SUNDRY NOTICES AND REPORTS ON WELLS
Do not use this form for proposals to drill or to re-enter an abandoned well. Use form 3160-3 (APD) for such proposals.

8. Well Name and No.
JACKSON B 45

**DRILLING PLAN
Jackson B 45 Deepening**

Jackson B 45
30-015-35398
Burnet Oil Co.
March 28, 2014
Conditions of Approval

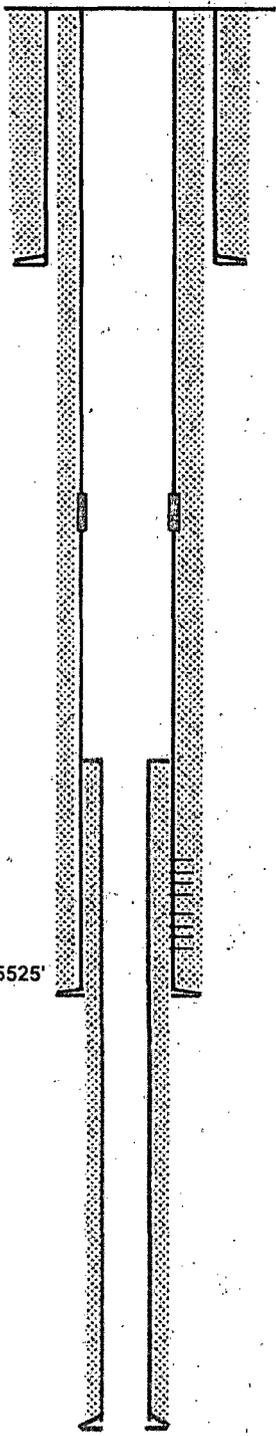
Proposed in Red

Liner Top/Tie Back Sleeve @ 4,100'

Squeeze perms with 300 sx before deepening

TD @ 6100'

5.5" 15.5# J-55 FJM
 in 6 1/8" hole
 150 sx

6. Variance for stand-off of less than 0.422" is approved due to NMOCD classifying the formations in this area as the Yeso group.
7. Cement on liner shall tie back to liner top, if this is not achieved contact appropriate BLM office. When plugged, cement plug will be required across this tie back and across squeezed perforations.
